Contract No. T201780203.01 Retrofit of BMP 75 on Lancaster Pike New Castle County

Enclosed is Addendum No. 1 for the referenced contract consisting of the following:

CONSTRUCTION DETAILS

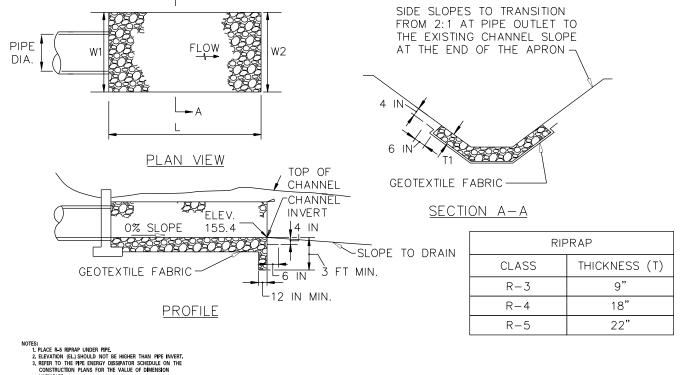
ADDENDUMS / REVISIONS **⚠TOPSOIL UPDATES - KSM 04/10/2018**
